MEMORANDUM 6/19/89

Subject: Preliminary Comments on the Colbert Landfill

Part I: Comments on the Present Hydrogeological Interpretation on
Colbert Landfill

Part II: Preliminary Comments on the Scope of Work, Phase I, Landau Associates

DATA FROM FALL/WINTER '85, '86
 COMPARE WITH THE 5-21 W/10000

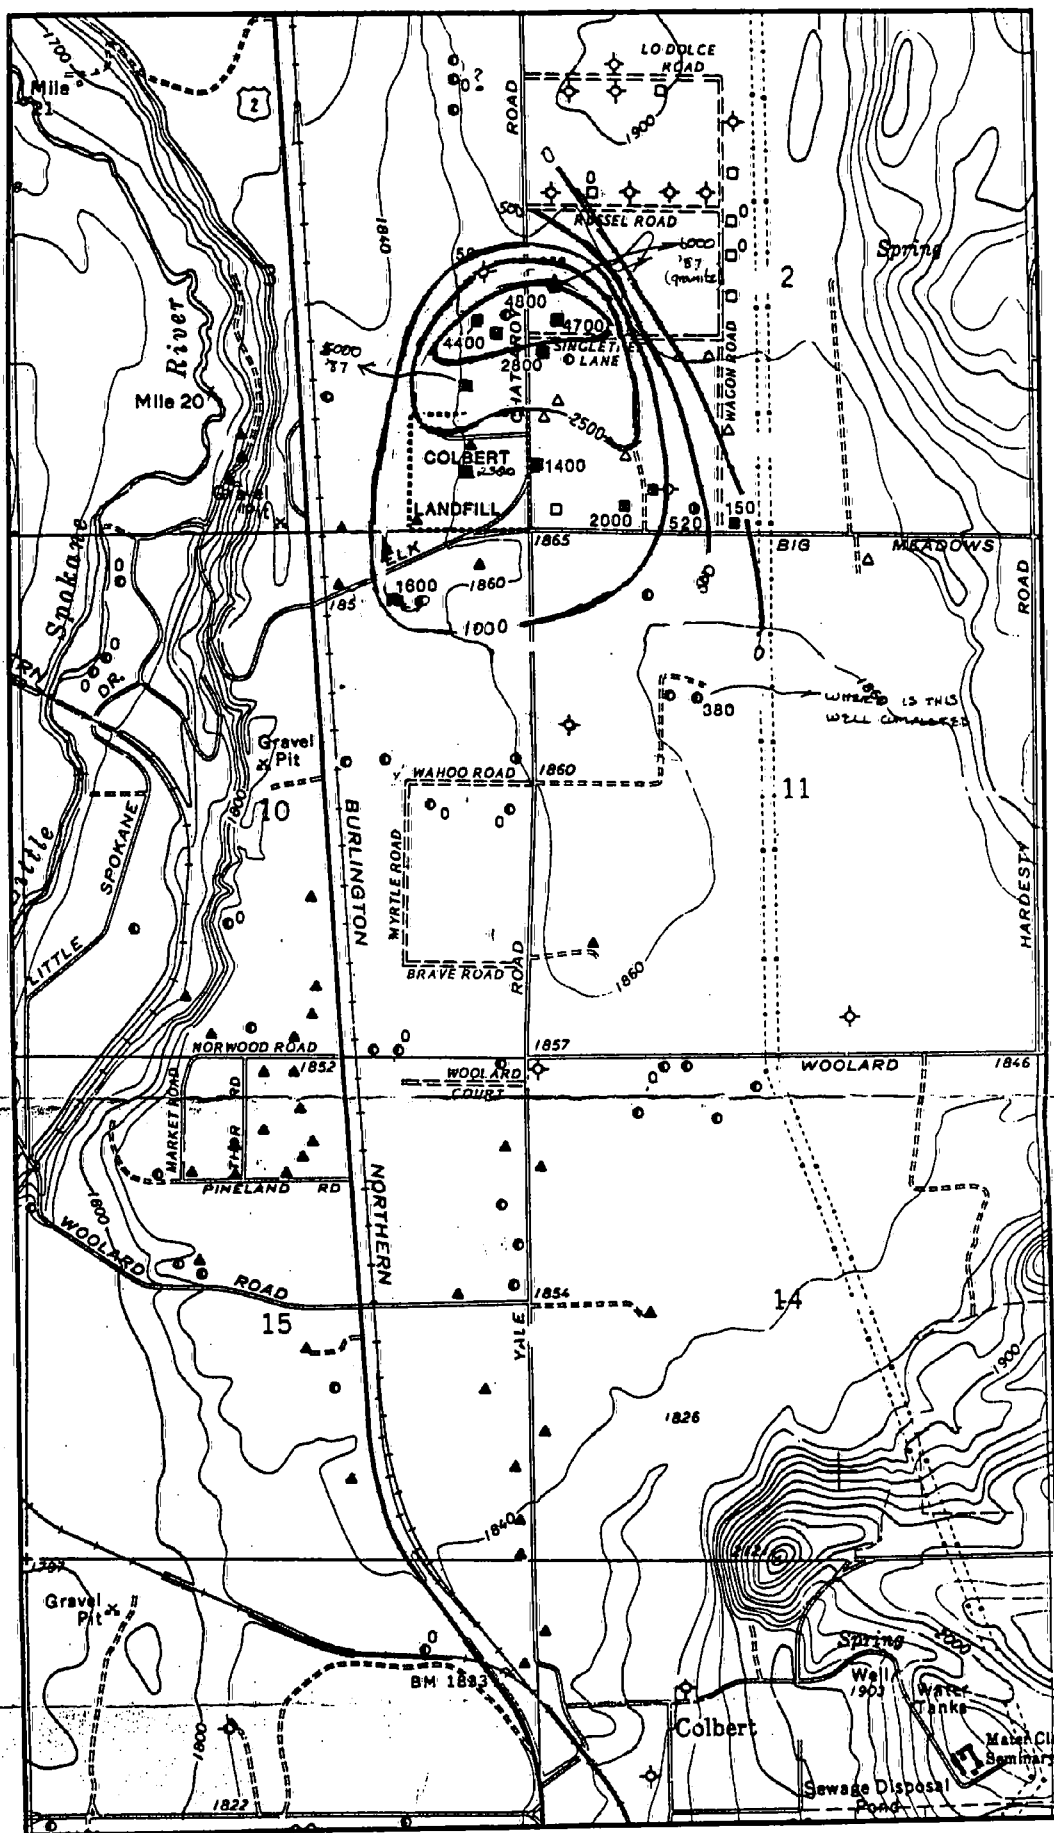
through 5-25 in the RI) need to be subdivided. These composite maps neglect the vertical distribution of contaminants within the lower units. Attached is a revised map modified from the RI (Golder, 1985 fig. 5-21) showing the concentration of TCA in unit D alone. Also attached is an annotated cross-section showing the vertical distribution of TCA. At most, these figures provide doubt as to the effectiveness of a western extraction system penetrating unit C alone. At a minimum, these figures demonstrate the necessity for the re-interpretation of existing information before deciding on the number and location of future monitoring and pilot wells.

Produce separate concentration maps for unit D

Figure 5-21

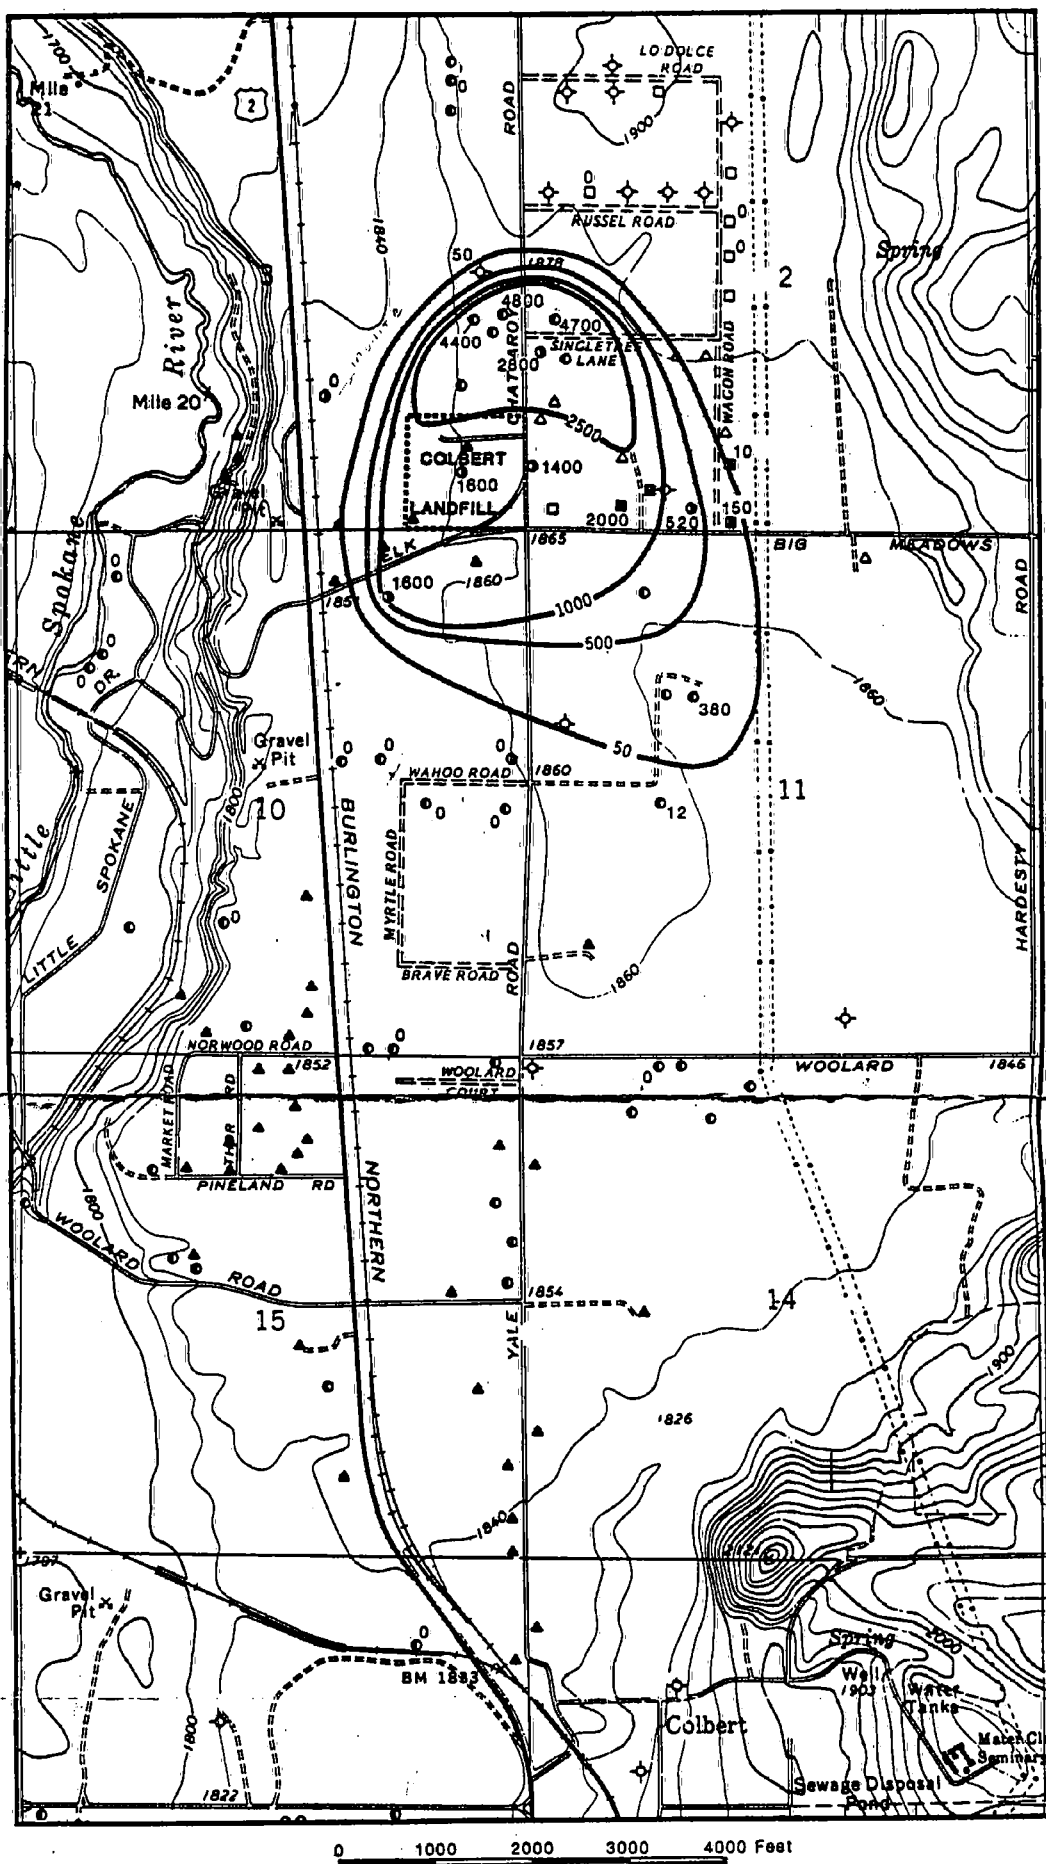
- 1) Chemical Concentration Maps and Water Level Maps
 - a) The chemical concentration maps presented in the RI (Golder, 1985) need updating.
 - b) The composite concentration maps for units C/D/E/F (fig. 5-21
